SERVICE INFORMATION BULLETIN

APPLICABILITY: 2015-20MY WRX STI
SUBJECT: Steering Rack Assembly- Design Change

NUMBER: 04-26-20
DATE: 12/03/20

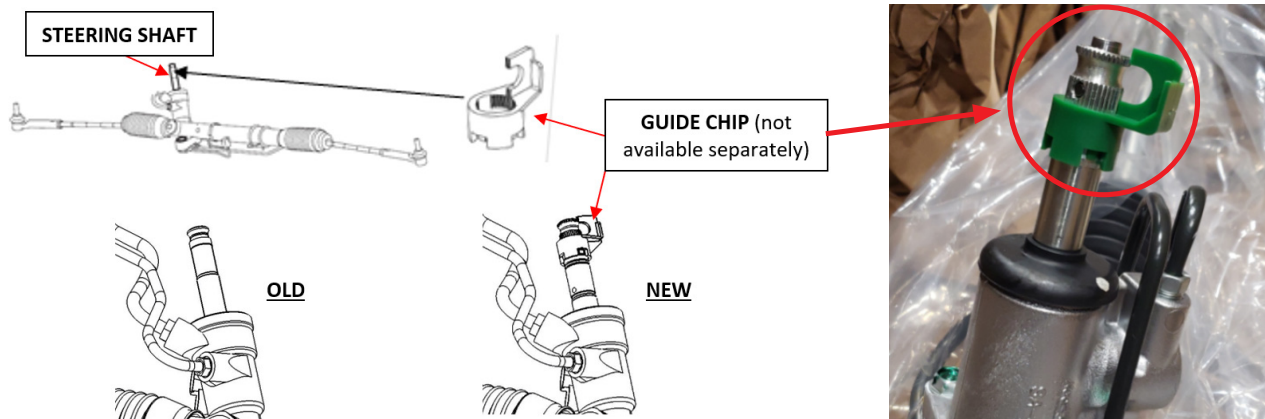
A plastic “Guide Chip” was added to the input shaft of the assembly to expedite proper spline alignment with the steering shaft during assembly as shown in the illustration below. When replacing the gearbox assembly in the field with one of these new parts (p.n. **34110VA132** or **34110VA141**), remove the guide chip before installation.
